**BID NO. SWA 11-230/MRK
INFRASTRUCTURE AND ROADWAY IMPROVEMENTS
ADDENDUM No. 2 – March 17, 2011**

CLARIFICATION TO RESPONSES ISSUED TO QUESTIONS/COMMENTS
AS PART OF ADDENDUM NO.1:

SOLID WASTE AUTHORITY OF PALM BEACH COUNTY
 PALM BEACH COUNTY, FLORIDA
INFRASTRUCTURE & ROADWAY IMPROVEMENTS

**WESTERN PERIMETER ROAD EXPANSION
 PLAN AND PROFILE**

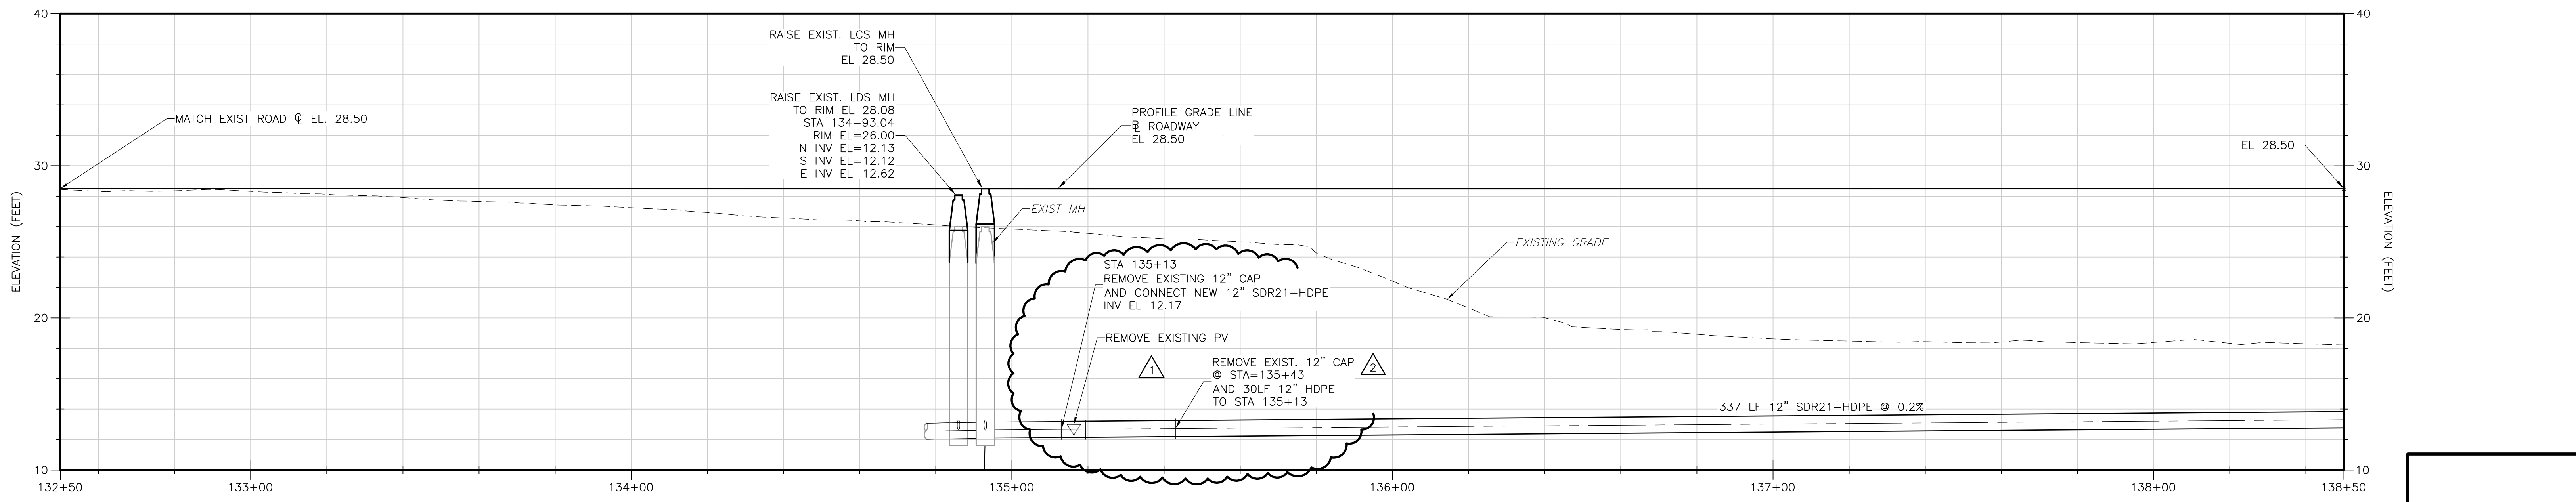
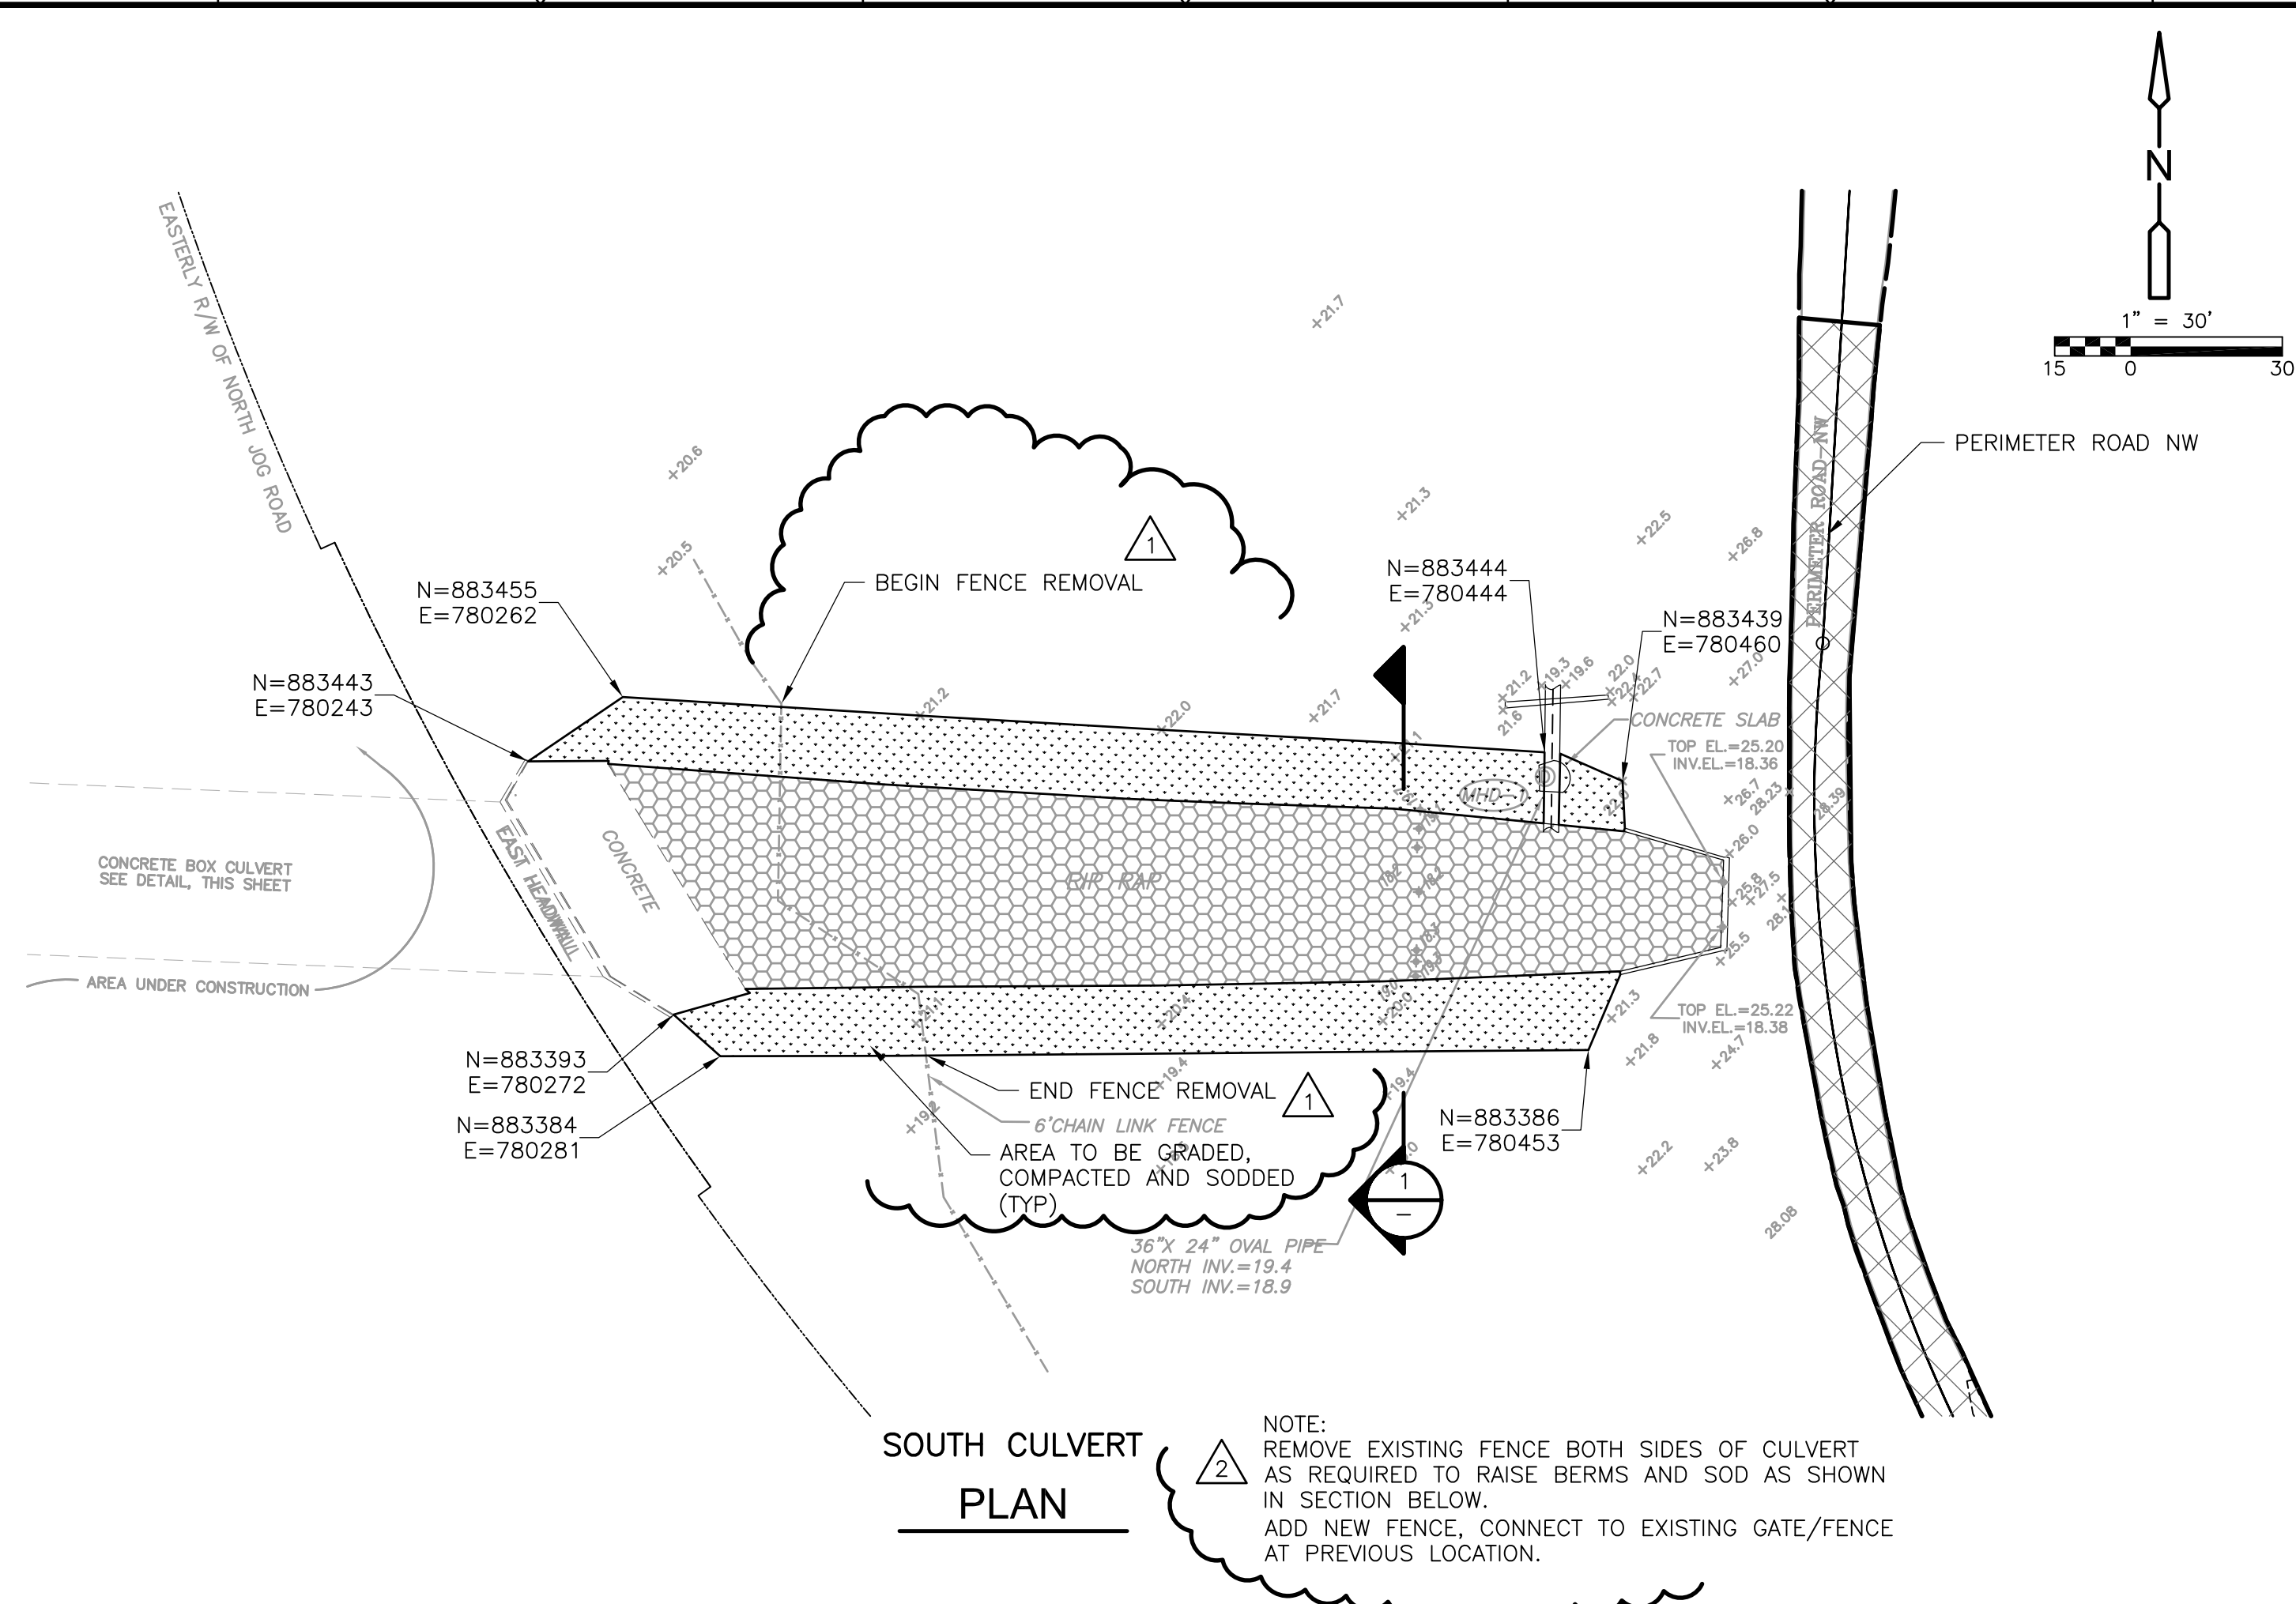
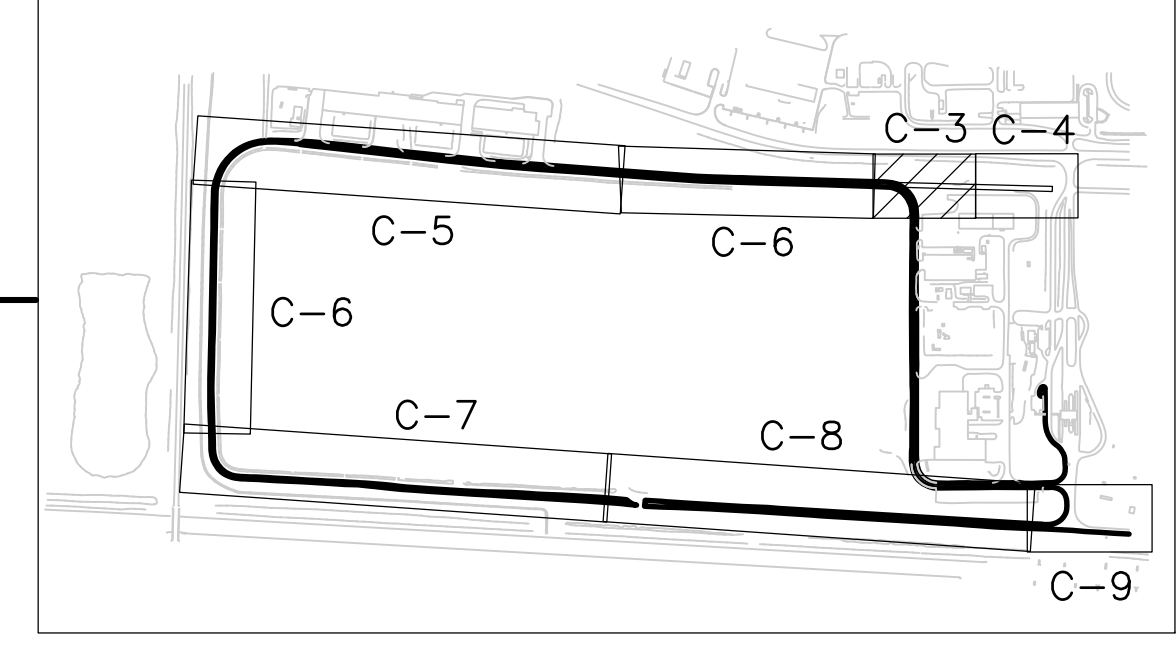
- 2. On sheet C-3 near Sta. 134+75 plans state "Raise Manhole Top" with Concrete pad. This location is an existing pump station with additional components like a control panel, etc.... Please provide complete set of details for everything to occur at this location.**

At Sta. 134+75, raise MH top, electric control panel, electrical vault, and meter box to elevation 28.5. Add concrete pad around all structures with top elevation 28.5. CONTRACTOR to reuse existing bollards to match future elevations. CONTRACTOR shall coordinate with ENGINEER during submittal process.
